ADMINISTRATIVE EXCEPTION/VARIANCE REQUEST APPLICATION

Project Name:	Crsecent Hills Unit 1
A/P # /PPR # /Plat #	AP# 2663409/ Plat#20-11800290
Date:	12/29/2020
Code Issue:	San Antonio Unified Development Code
Code Sections:	35-523 (h), Table 523-1A Minimum Tree Preservation Requirements

VARIANCE REQUEST ANALYSIS

TPV 21-024

CRESCENT HILLS UNIT 1
 SAN ANTONIO, TEXAS
TREE VARIANCE EXHIBIT

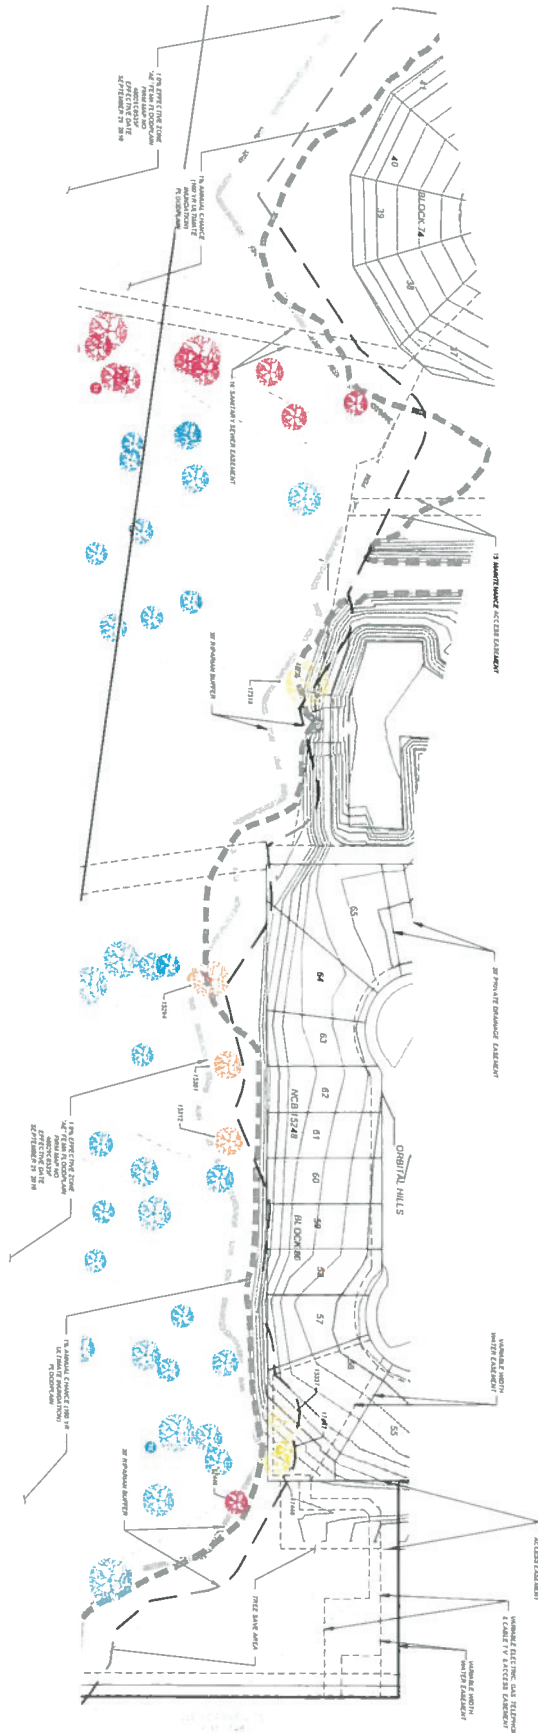
The applicant is requesting a Variance Request to mitigate for removal of surveyed trees within the Riparian Buffer in excess of the 80% minimum preservation of protected significant trees in place under the 2010 Tree Preservation Ordinance for development of the Crescent Hills Unit 1 Subdivision. DSD staff does agree with the applicant's request to mitigate for below 80% significant tree preservation through planting for the following reasons:

1. *Existing site conditions* – Due to existing site conditions and the need to comply with the Atlas 14 floodplain delineation and UDC guidelines, excess embankment will be necessary to achieve both proper drainage within each lot and proper detention on the overall site. The extreme mass grading required for the ultimate development of the site has made it a challenge to preserve some of the very few trees that are located within the 30-foot Riparian Buffer (Environmentally Sensitive Areas or ESA). The applicant used the tree survey method which determined that the predominant tree species found within the Riparian Buffer is Mesquite. The minimum diameter of a protected Mesquite tree is 10" and the average diameter found was 14.5". There were 6 Mesquite trees and 1 Elm tree surveyed within the ESA which total 95.5 inches. Four trees will be removed resulting in 42% preservation, and to mitigate back up to 80%, a total of 36.4 inches in mitigation is required.

In summary, the proposed project will result in 91% tree preservation in the floodplain and 42% preservation in the Riparian Buffer. Within the FEMA floodplain, no reclamation will occur for this project; therefore, tree preservation will exceed the minimally required 80% in the floodplain portion resulting in an excess of 774 inches.

2. *Tree mitigation and canopy diversity* – The project will meet the ESA/Riparian Buffer mitigation requirement of 36.4 inches by up-sizing required streetscape trees and providing a final canopy cover of 39.92%.
 - a. 43 streetscape trees upsized from 1.5" to 3.0" = 64.5 inches available for mitigation
 - b. A total of 28.1 additional inches of mitigation beyond minimum requirements will be provided
 - c. Exceed final tree canopy requirement by 0.89 acres = 39.92% (required final canopy = 38%)

DSD staff supports the applicant's request to fall below 80% Significant Tree requirements in the ESA based on the conditions of the site, required grading, and exceeding mitigation and final tree canopy requirements. The proposed Variance Request meets the intent and spirit of the Tree Ordinance therefore, staff recommends approval.

RECOMMENDATION: Approval of Variance Request

Exhibit 1

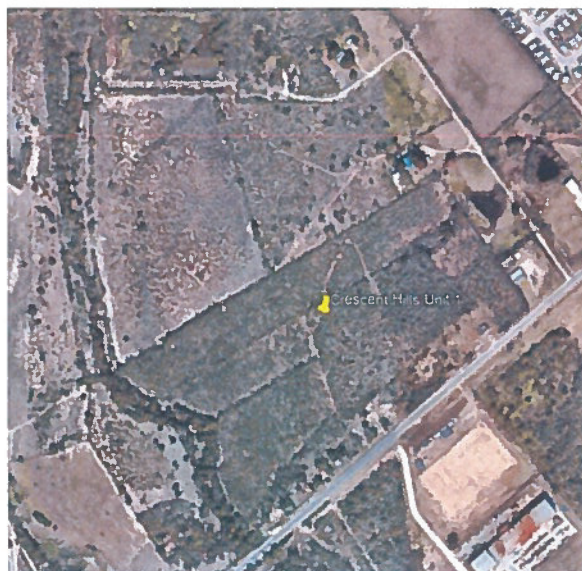
At existing conditions, the project site is moderately wooded with a canopy cover greater than or equal to 70%. The topography ranges from 0%-10% and is located adjacent to the Federal Emergency Management Act (FEMA) floodplain. **Exhibit 1.**

Due to Atlas 14 floodplain delineation, the proposed site had to be embanked to properly detain runoff and meet UDC regulations. However, this also made it unable to preserve some existing trees. Extreme topography and the existing features of the site including a pond and a stream running through the site, excess excavation and embankment is necessary for the improvement of the existing channel and for this development. The mass grading of the proposed site is problematic because it results in the inability to preserve some of the very few trees that are located in the 30' Riparian Buffer.

No reclamation of the FEMA floodplain will occur for this project; therefore, more than the minimum requirement of floodplain trees are preserved. However, the **80% preservation could not be attained within the 30' Riparian Buffer/Environmentally Sensitive Area**. There have been many attempts to revise the proposed site configuration and grading plan to preserve additional significant species trees in the environmentally sensitive area. However, with numerous alterations to the site none effectively stay in compliance and demonstrate the intent of the Unified Development Code. **Reference Tree Preservation Table.**
